Drinking Water Audit Report

County:	Mayo	Date of Audit:	15 th May 2015
Plant(s) visited:	Lough Mask RWSS	Date of issue of Audit Report:	20 th May 2015
		File Reference:	DW2007/464
		Auditors:	Mr. Darragh Page
Audit Criteria:	<ul style="list-style-type: none"> • The <i>European Union (Drinking Water) Regulations 2014 (S.I. 122 of 2014)</i>. • The <i>EPA Handbook on the Implementation of the Regulations for Water Services Authorities for Public Water Supplies (ISBN: 978-1-84095-349-7)</i> • The recommendations specified in the <i>EPA Drinking Water Report</i>. • The recommendations in any previous audit reports.

Photo 5. Turbidity Readings from Filters No1 to 8 during the period 20th-28th March 2015.

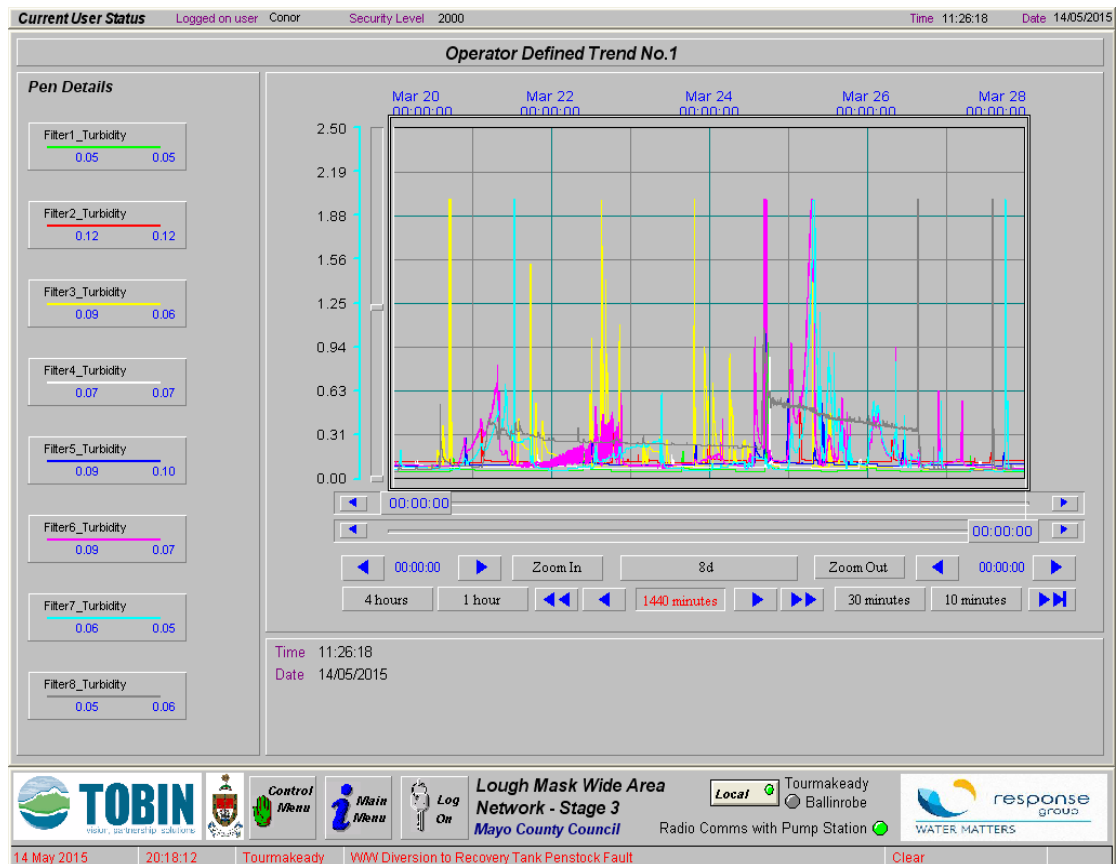
3.	<p>Filtration</p> <p>a. The clarified water is distributed to 8 no. rapid gravity filters. These consist of 4 older filters and 4 new ones installed as part of the recent upgrade completed in 2014.</p> <p>b. An extensive examination of the performance of the filters was carried out during the audit looking at the results from the turbidity monitor for each filter from 1st March 2015 to the 15th May 2015.</p> <p>c. Significant issues in the performance of some of the filters were observed, in particular filter no. 7 as detailed below.</p> <p>d. There is inadequate control over the turbidity alarms at present. With the current set up of</p>

<p>the SCADA the backwash process can only trigger on an instantaneous result. MCC explained that an instantaneous high result could be anomalous and could occur regularly if the level was set at the normal operational level of concern (i.e. 0.2 NTU). To overcome this SCADA set up gap, the backwash trigger was set to activate if the turbidity levels rise above 2 NTU on an instantaneous result. There is also a warning alarm which activates if the turbidity levels go above 0.2 NTU for more than 30 mins, however, this cannot, at present, be set up to trigger a backwash. It means that if levels rise above 0.2 NTU but remain below 2.0 NTU poor quality filtered water could enter supply for a period of time (this is a particular risk when the plant is unoccupied at night).</p> <ul style="list-style-type: none"> e. There is also inadequate control over filter levels resulting in incidents where individual filters (particularly no. 7) run dry or are flooded. Where such incidents occurred the levels of turbidity on the affected filter rose significantly. This problem is particularly acute when another filter has to be taken out of service for a period. For example, an incident with the penstock on filter no.8 on 20th March 2015 could not be properly repaired until 26th March 2015. During this period turbidity levels on the other filters was poor due to the effect of taking filter no.8 out of service (see Photo 5 for turbidity readings during this period). This led to levels of >1.0 NTU coming through some of the filters on occasion and particularly filter no.7. A repeat of a related incident occurred on 27th, 29th (see Photo 6) and 31st March 2015, 2nd, 11th and 12th April 2015. f. Other incidents of elevated levels of turbidity include (but were not limited to) 3rd March 2015 (due to cold weather and floc carryover), 15th-16th March 2015 (filter flooded), 13th April 2015 (filter no. 7 ran dry) and 7th May 2015 (filter ran dry). g. IW stated that the scope of the necessary improvement works for filter control had been drawn up and a quote obtained to carry out these works. IW stated that these works could be completed in the next 4-6 weeks. h. A backwash of filter no.8 was carried out and no issues with the backwash were observed.

There are significant operational issues at the Lough Mask Water Treatment Plant that present a risk of filter breakthrough which could result in *Cryptosporidium* entering the supply if present in the raw water. Specifically, SCADA controls and operation of the filters requires urgent attention as it is clear that there are regular occurrences of elevated turbidity breakthrough on various filters (but most notably filter no.7).

4. Irish Water should carry out the necessary remedial works to the filter controls to ensure that incidents of breakthrough on the filter are minimised. These works should include a review of

alarms and control of alarms, filter levels and loads. Irish Water should outline what actions are to be taken to address the issues identified during the audit.

5. Following the remedial works to the filter controls Irish Water should implement revised procedures for the management of the filters including details of when filters should run to waste or are backwashed to prevent a risk of *Cryptosporidium* breakthrough.
